Applicant:	Strong et al	§
		§ Art Unit: 3653
Serial No:	10/774,303	§
		§ Examiner: Joerger, Kaitlin S.
Filed:	6 Feb. 2004	§
		§ Atty Docket No: SC 082
For:	Shaker Screen and Clamping System	§
		§ Conf. No. 5404
		§

RESPONSE TO OFFICE ACTION MAILED 2/28/2006

Marked-Up Specification Pages 18, 19

US Ser. No. 10/774,303
 Marked-Up Sheet showing changes

Fig. 55B

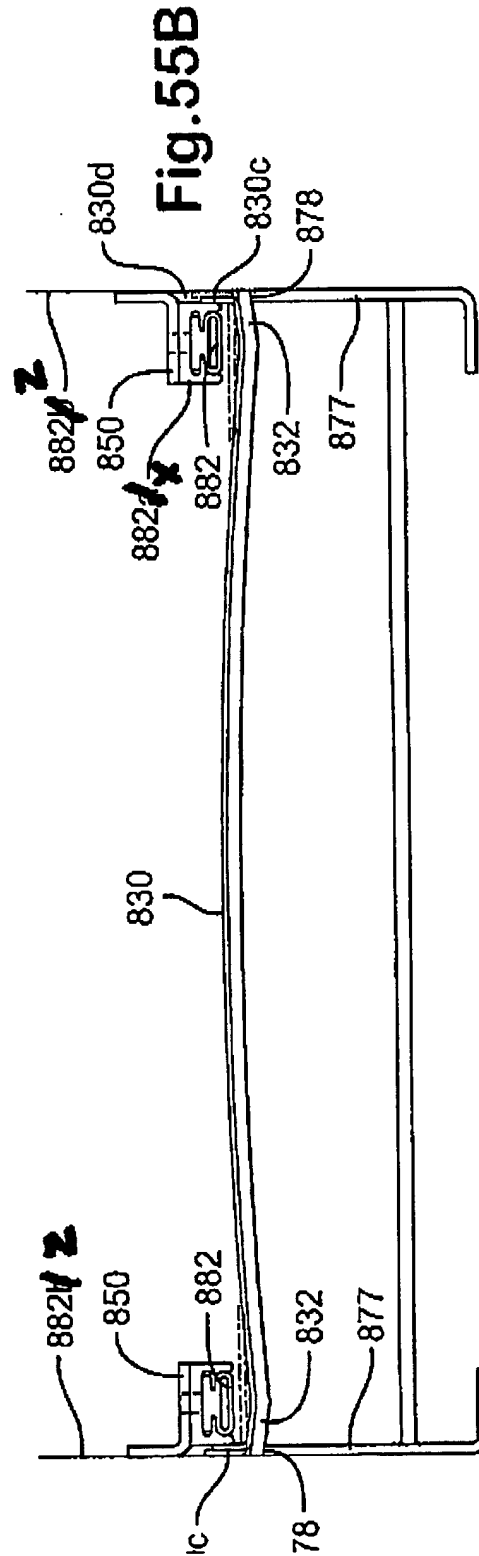
830c Fig. 55B

830d Fig. 55B

Numerals 882a and 882b remain which are used to indicate the bladders, uninflated and inflated. The brackets on Page 19, line 7 of the Specification are now indicated by numeral 882x; and the walls on Page 19, line 8 are now indicated by numeral 882z. Marked-up and replacement pages 19 are submitted herewith, along with a replacement drawing sheet with corrected Fig. 55B with new numerals 882x and 882z.

94. As shown in Fig. 55C, the screen assembly 830 may, optionally, have side lips or hooks 830c which are selectively
5 releasably positionable in gaps 830d between brackets ~~882a~~ 882x holding the bladders 882 and side walls ~~882b~~ 882z of a vibratory separator. Any known shape or configuration for any known hookstrip and/or hooks may be used with associated well-known hook or hookstrip holding apparatus.
